05V-018  
(10 pages)

# Recall Bulletin

**SUBJECT: INTERMEDIATE STEERING SHAFT TO STEERING GEAR BOLT**

**MODELS: 2005 CHEVROLET SILVERADO  
2005 GMC SIERRA**

333148

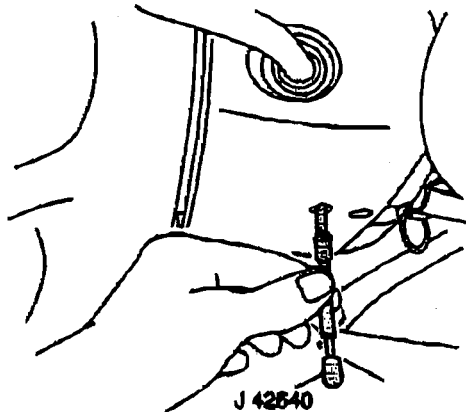
General Motors has decided that a defect, which relates to motor vehicle safety, exists in certain 2005 Chevrolet Silverado and GMC Sierra vehicles. The bolt that attaches the intermediate steering shaft to the steering gear may not meet specification. The bolt may fracture, resulting in the loss of steering. If this happens while the vehicle is moving, a crash could occur without prior warning.

Dealers are to replace the intermediate steering shaft to steering gear bolt.

2. Install J 42640 in the steering column lower access hole.
3. For vehicles equipped with a 6.6L diesel engine, remove the left charge air cooler hose.
4. Remove the bolt from the lower shaft coupler.
5. Install the new bolt to the lower shaft coupler. **Tighten**

Tighten the coupler pinch bolt to 47 N·m (35 lb ft).

6. For vehicles equipped with a 6.6L diesel engine, install the left charge air cooler hose.
7. Remove J42640 from the steering column lower access hole.
